UDPRP Review Summary **DRAFT 05.21.21**

Urban Design Peer Review Panel

Below is a summary of the Urban Design Peer Review Panel's advice for the Pearl Lofts project as derived from the May 21st Peer Review session.

PEARL LOFTS
DALLAS, Texas

JAN PRUIT WAY ELEVATION
1" = 20' 0"

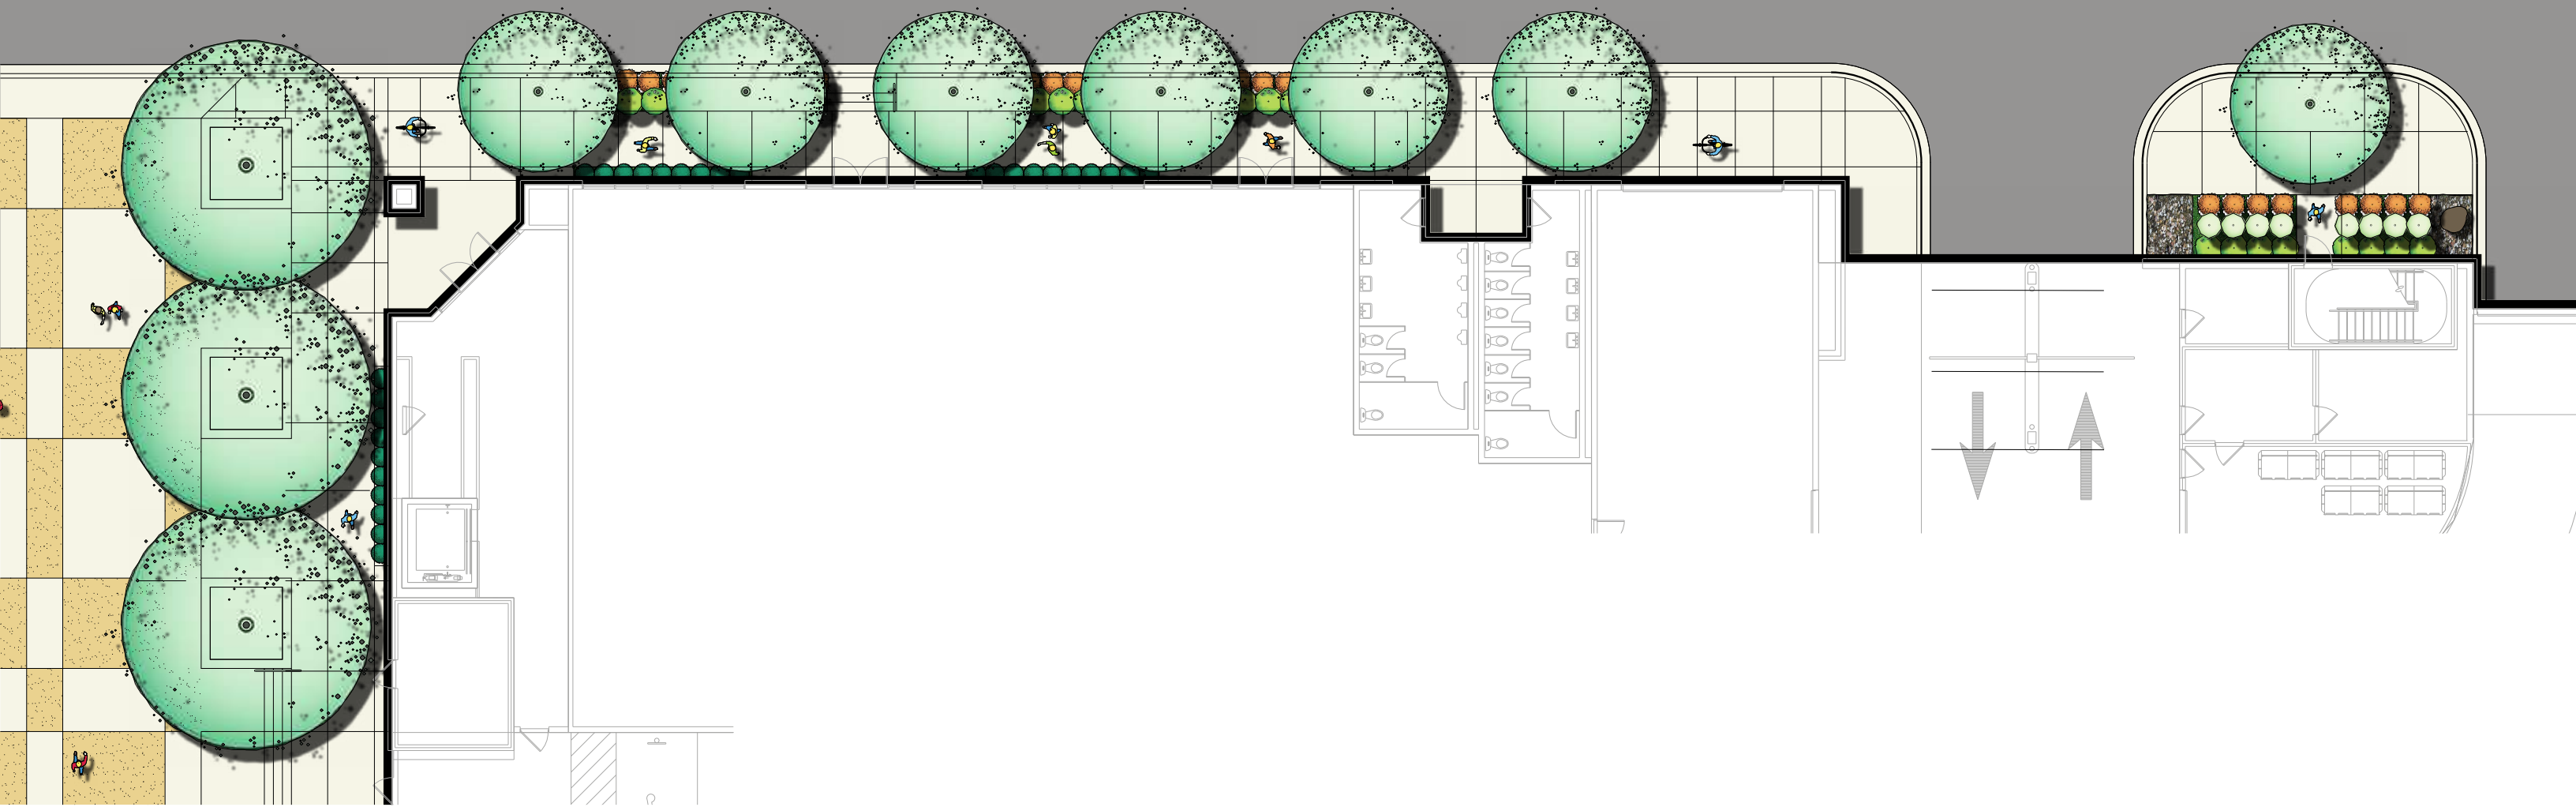
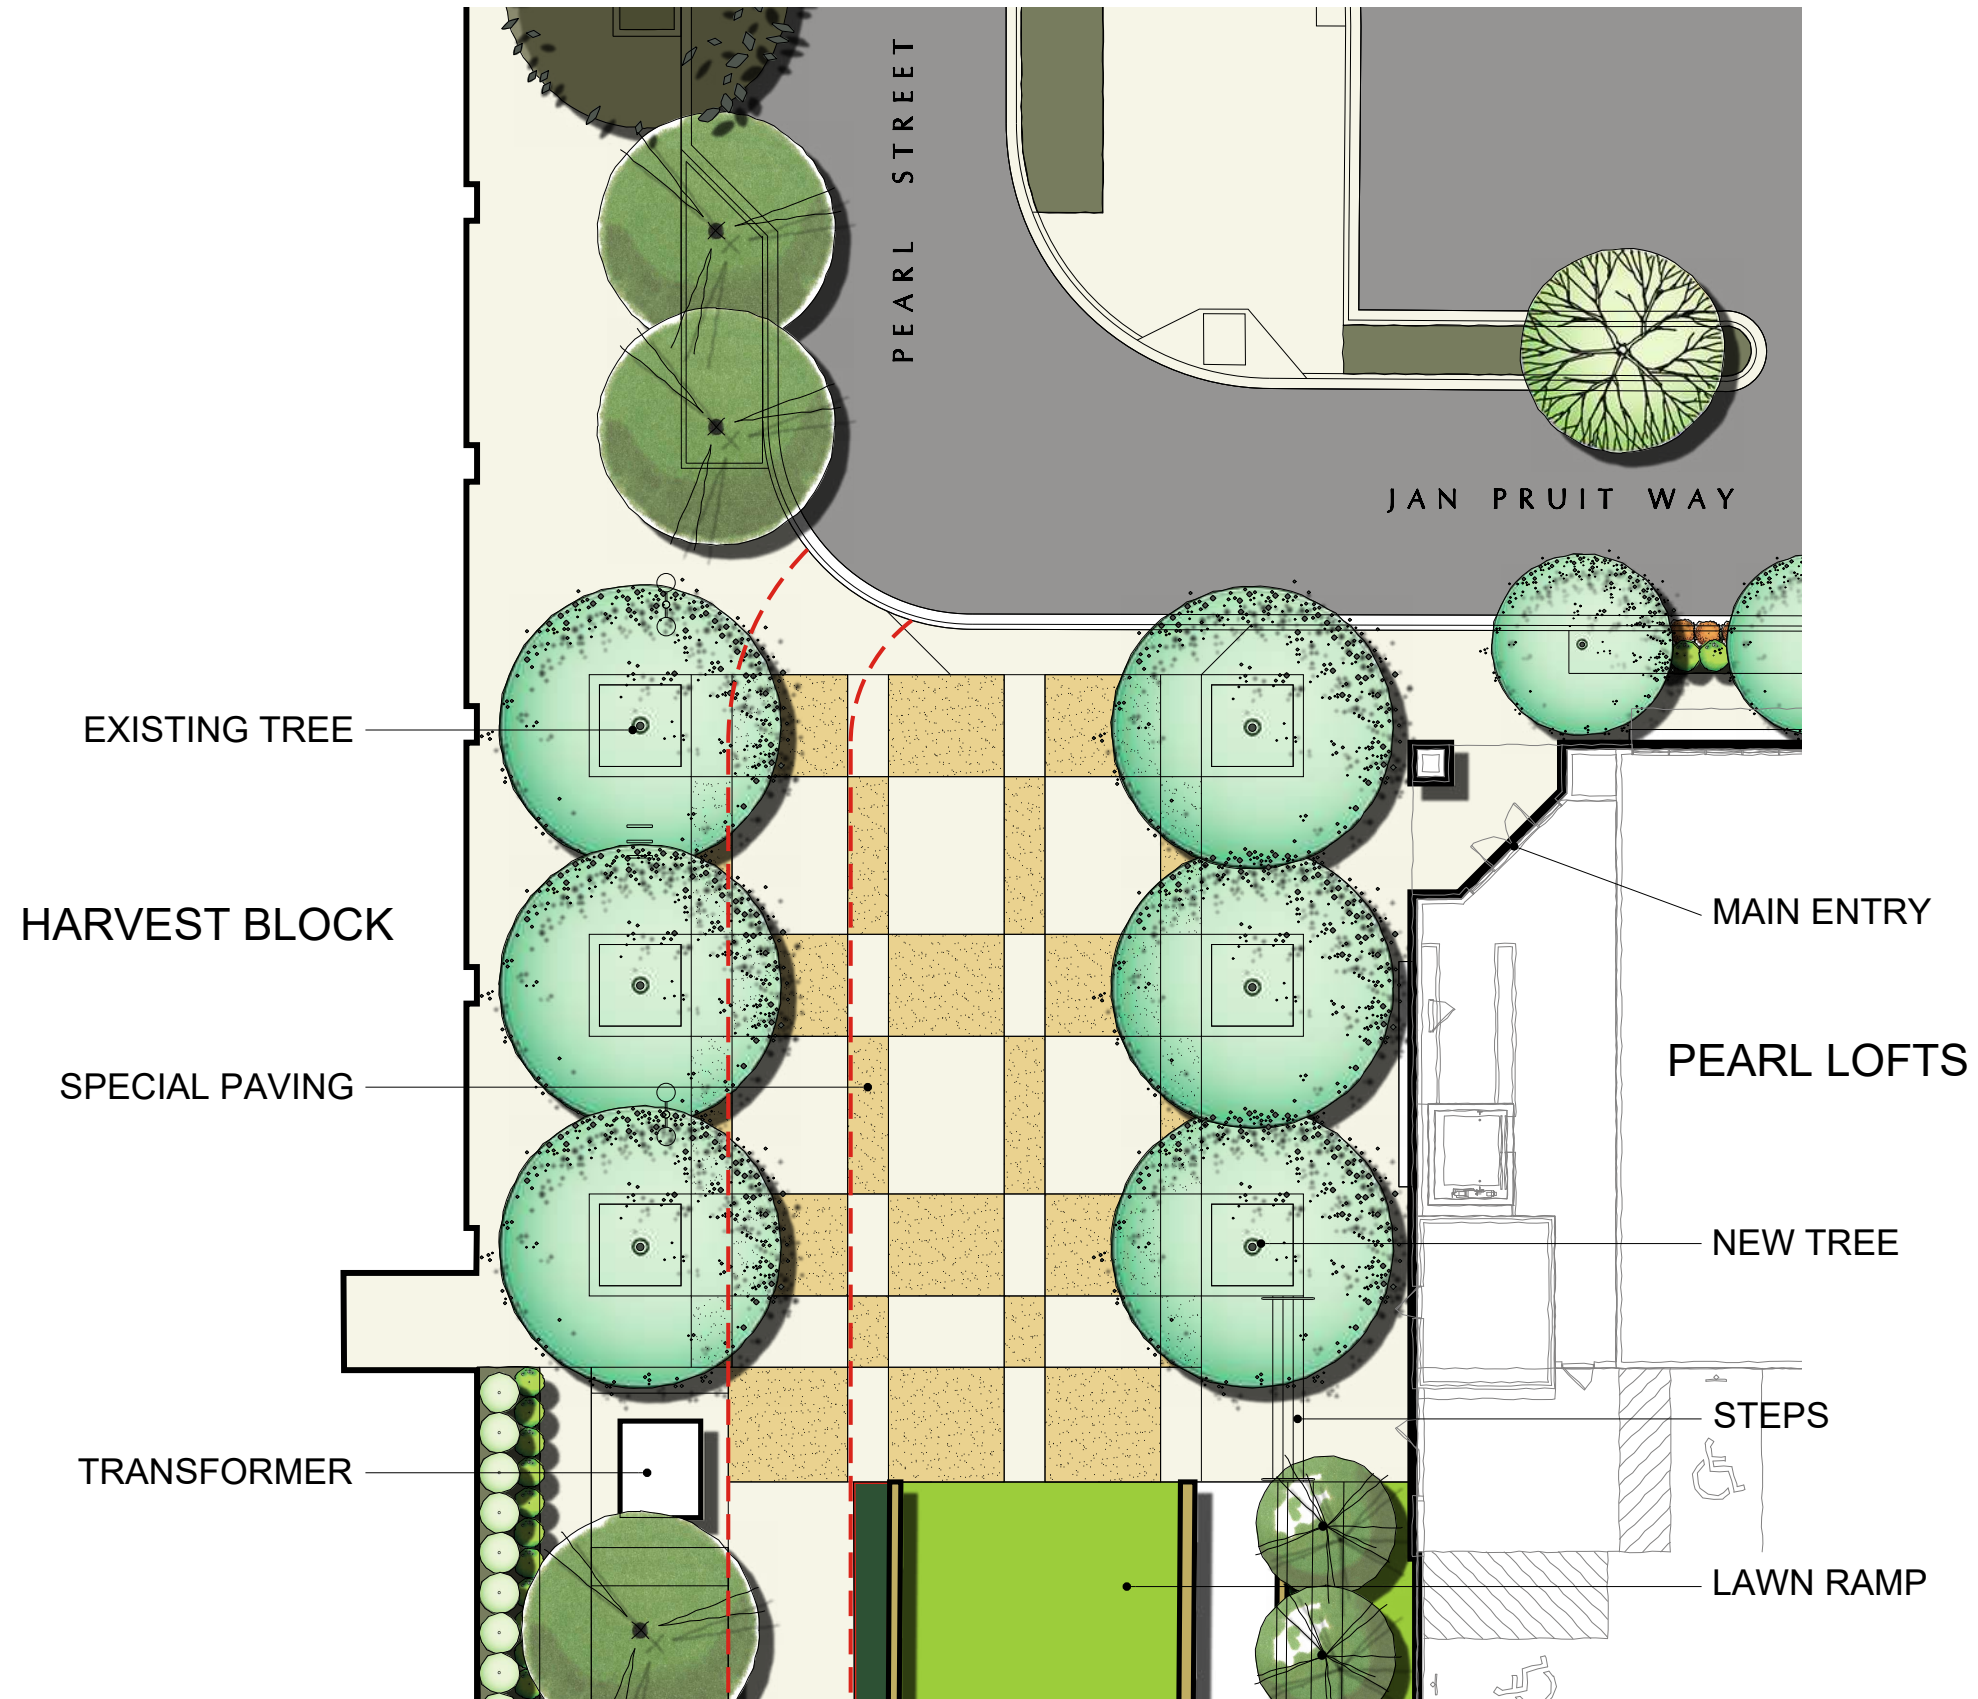
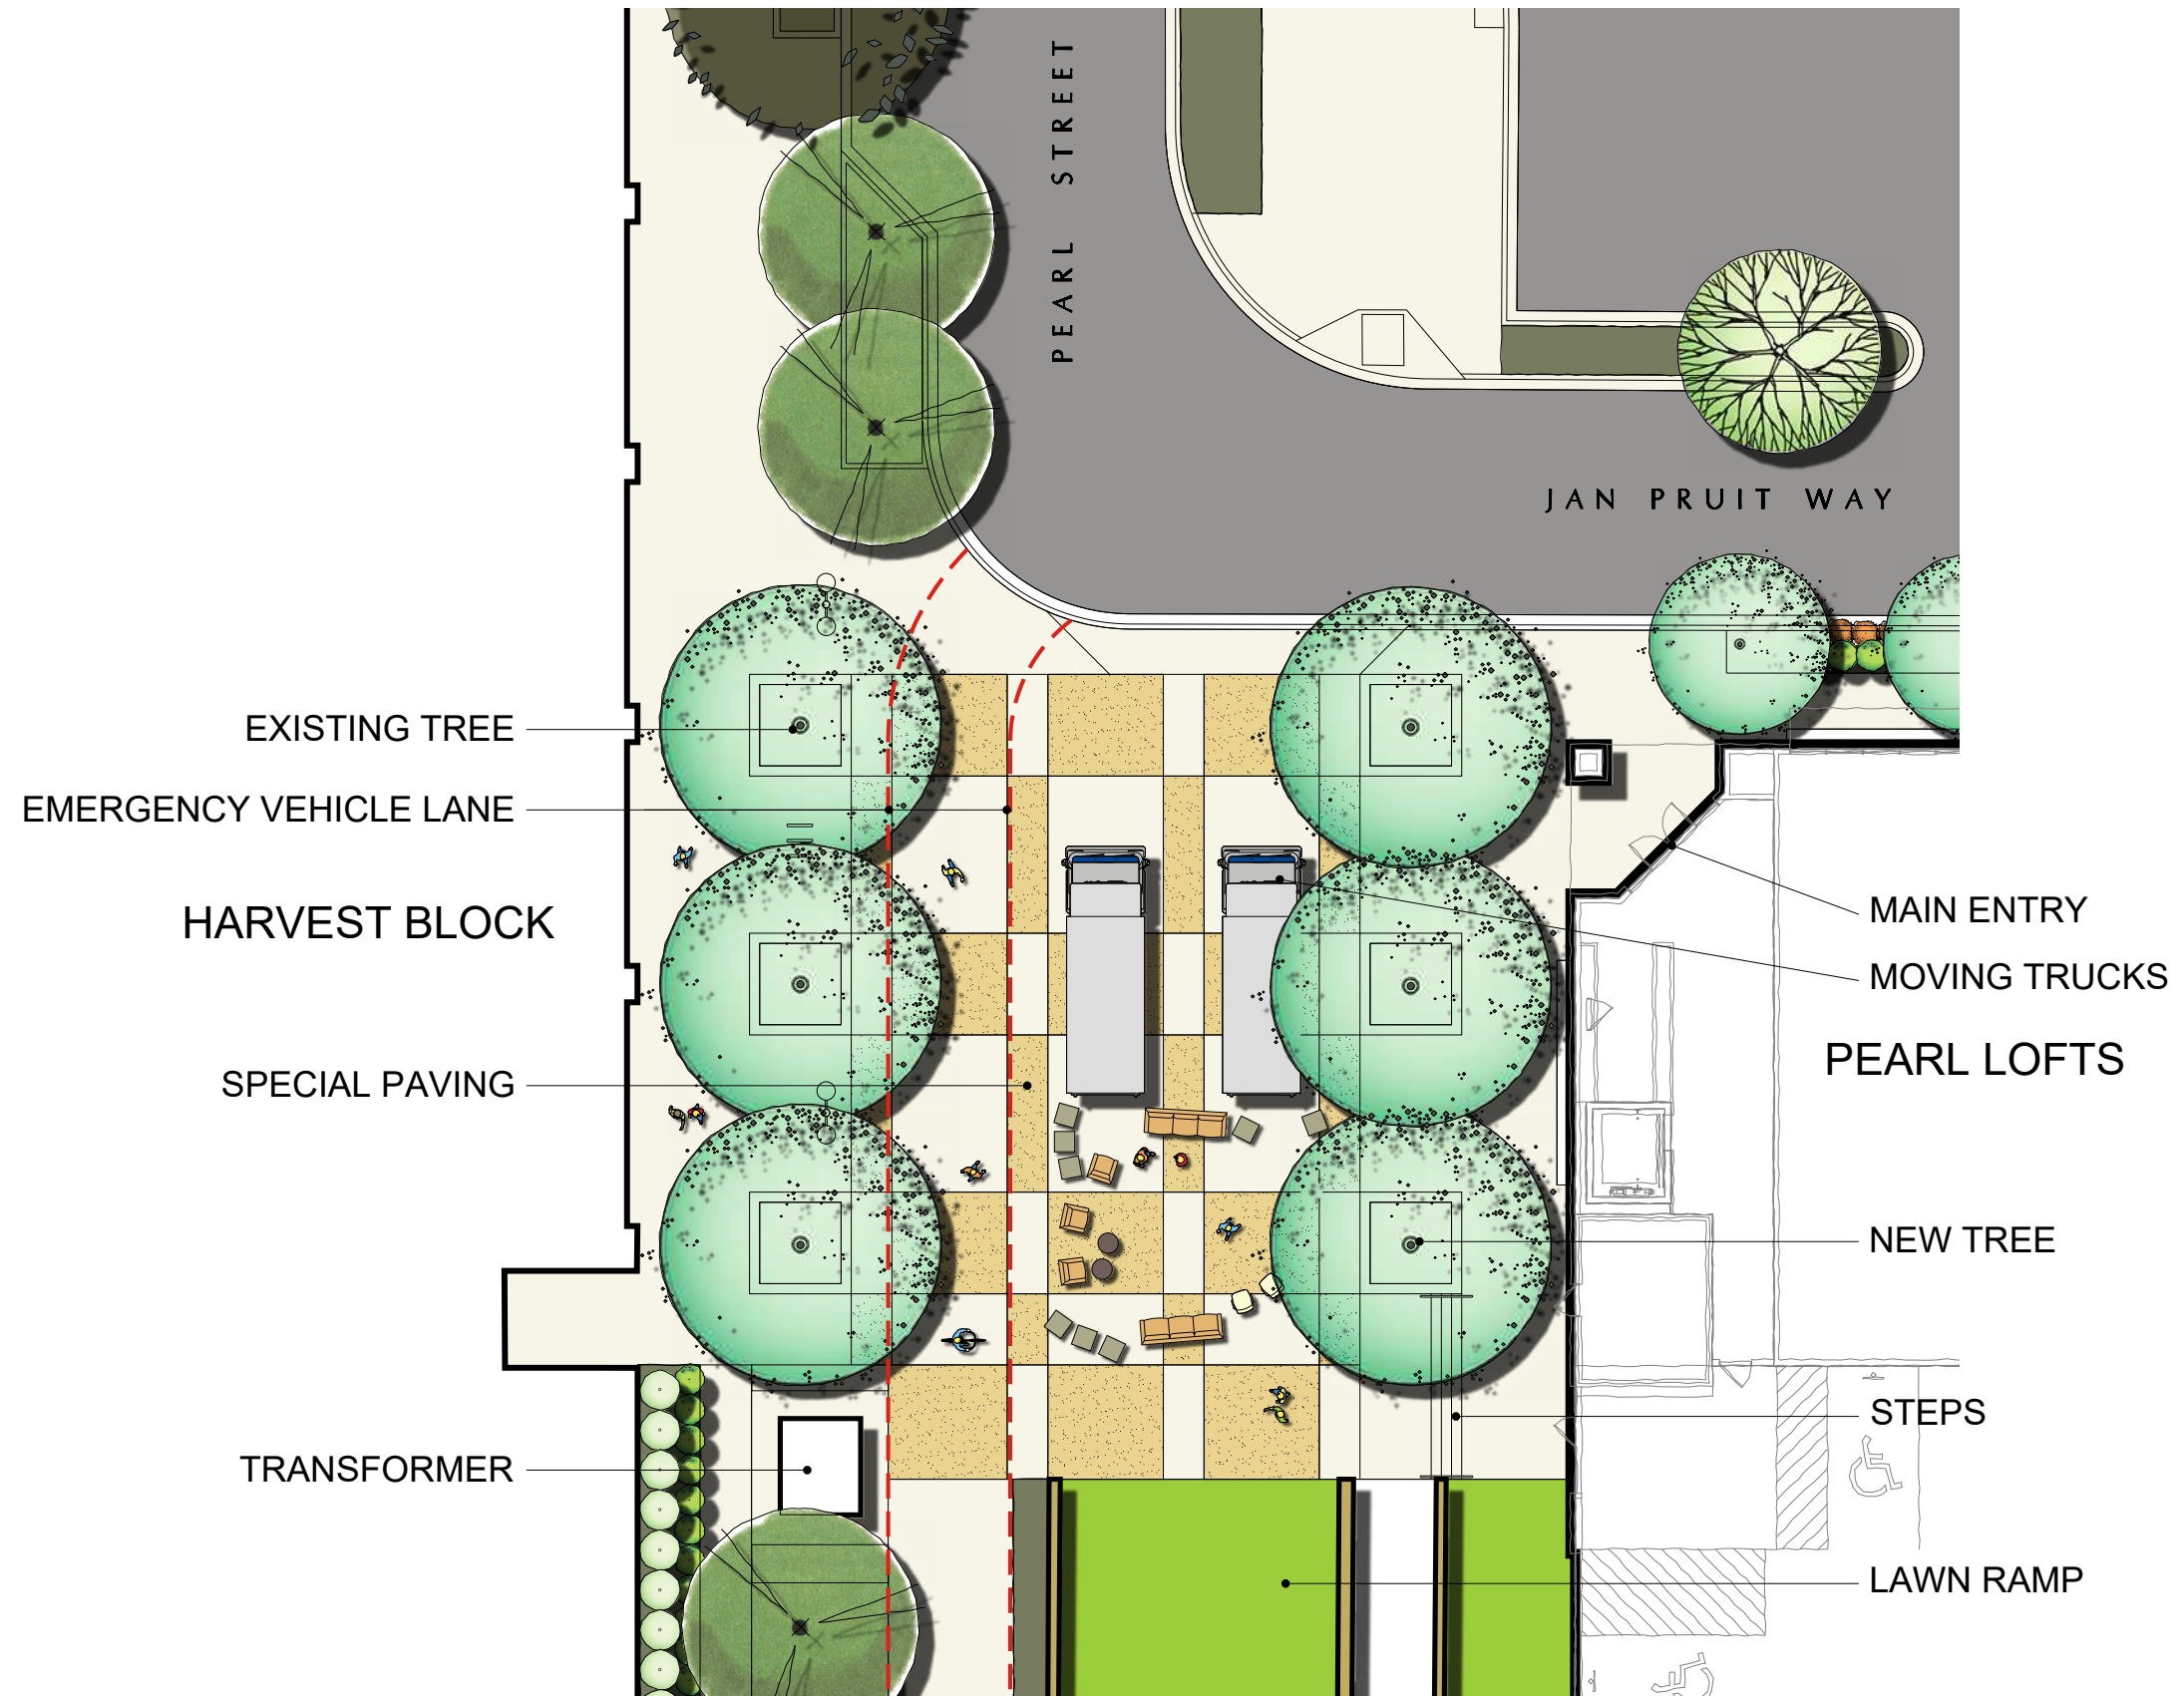
- [4] The Panel suggests the design team further explore the design of the ground-level along Pearl Street and Jan Pruitt Way to provide more transparency and activity along those facades to reinforce the pedestrian nature of this district.

- [6] The Panel recommends that further design refinement be given to the streetscape along Jan Pruitt Way to create a more inviting pedestrian space, including replacing the landscape buffer with tree wells and giving more focused design to the driveway entries into the garage.

- [7] The Panel suggests further design refinement be given to the design of the parking garage façade on all sides to further screen the parking uses and improve the proportionality between openings on the First and Second floors.
